Point Beach Nuclear Plant, Units 1 and 2
Dockets 50-266 and 50-301
Renewed License Nos. DPR-24 and DPR-27

Response to Request for Additional Information
License Amendment Request 241
Alternative Source Term

**RESPONSE TO REQUEST FOR ADDITIONAL INFORMATION
LICENSE AMENDMENT REQUEST 241
ALTERNATIVE SOURCE TERM**

**Figure 1: Supplemental SGTR Dose Analysis
RCS and Secondary Pressures**

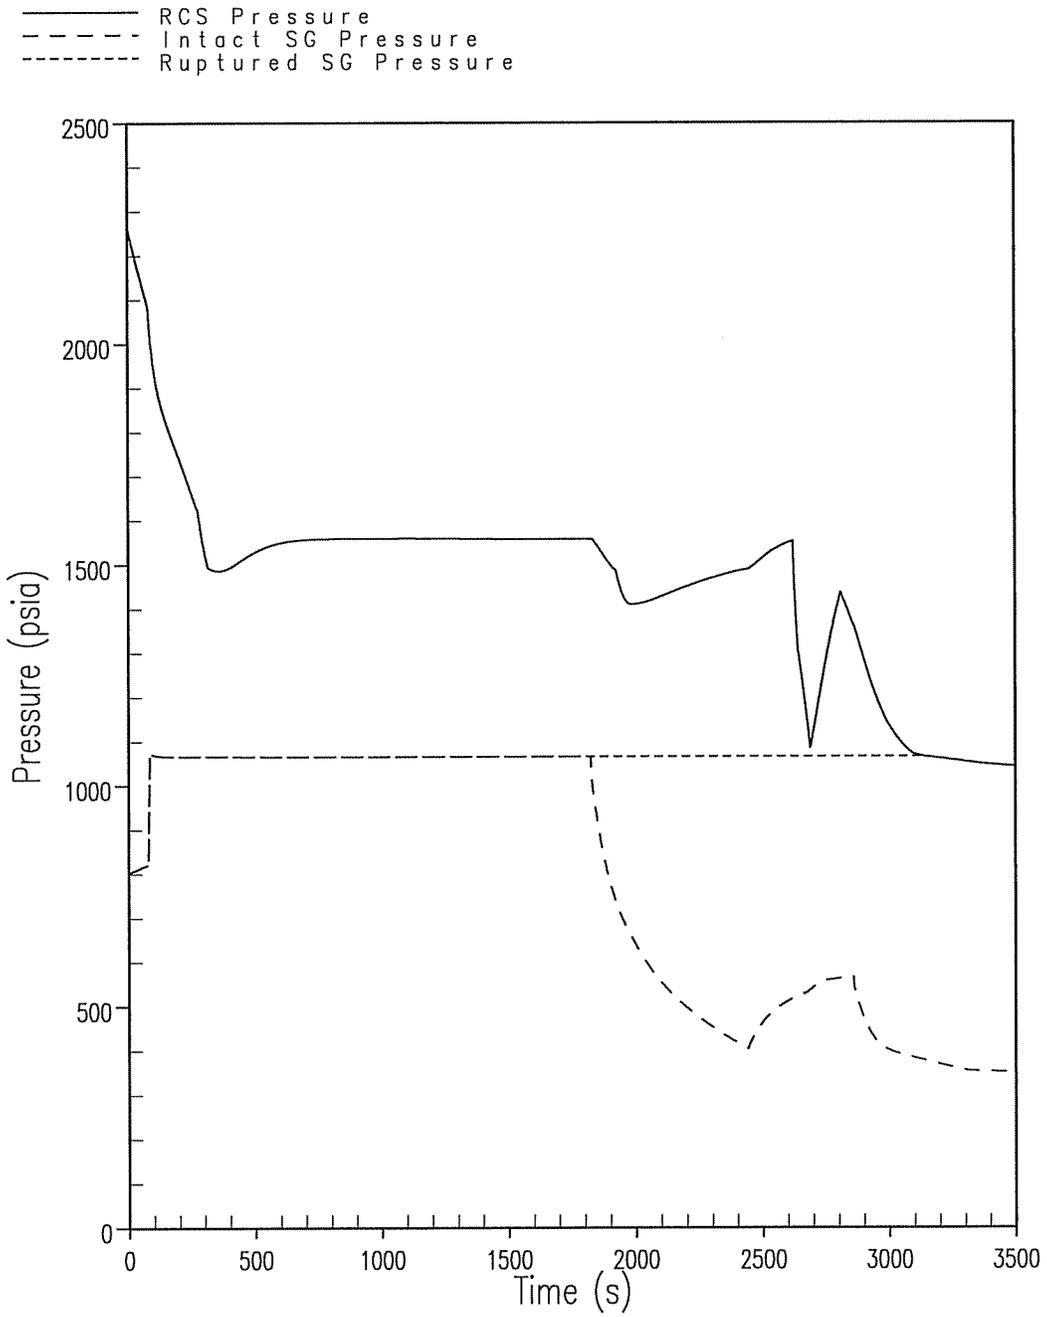
Discuss the SGTR mitigation strategy credited in the analysis and provide the basis for the mitigation strategy. Provide a sequence of the event listing the operator actions credited in the SGTR analysis and justify adequacy of the assumed operator actions and associated times. Also, discuss the computer code used to determine the margin to SG overfill and show it is an NRC-approved code. In addition, discuss whether the methodology documented in WCAP-10698 is applicable and needed to apply to the Point Beach plant for the SG overfill prevention or not. The Point Beach plant and Ginna plant are Westinghouse two-loop plants with similar rated thermal power levels. Among other Westinghouse plants, Ginna performed and NRC approved the SGTR reanalysis using the WCAP-10698 methodology. If the licensee determines that the WCAP methodology is not applicable and a reanalysis of the SGTR event is not needed, provide rationale for the determination. If the licensee determines that the reanalysis using the WCAP methodology is needed, it should provide the results of the SGTR reanalysis to the NRC staff for review.

The supplemental SGTR dose analysis modeled 0% tube plugging and 577°F RCS average temperature with the Unit 2 Model $\Delta 47$ steam generator (bounding for Unit 1). The evaluation included consideration of a maximum safety injection flow rate and a minimum auxiliary feedwater flow rate. The calculated sequence of events is presented in Table 2 which shows break flow termination in approximately 53 minutes. Figures 1 through 6 contain plant transient responses to the tube rupture event including primary and secondary pressure, primary-to-secondary break flow, primary-to-secondary flashing fraction, and secondary steam releases. Table 3 compares the dose consequences calculated using the results of the 30-minute licensing basis analysis as presented in LAR 241 to the dose consequences calculated using the results of the supplemental SGTR dose analysis. The doses were calculated using identical assumptions with the only difference being the mass transfers used as input. The resulting doses for the supplemental SGTR dose analysis with break flow termination at 53 minutes are lower than those presented in LAR 241. Thus, the supplemental SGTR dose analysis confirms that the dose analysis presented in LAR 241 is bounding.
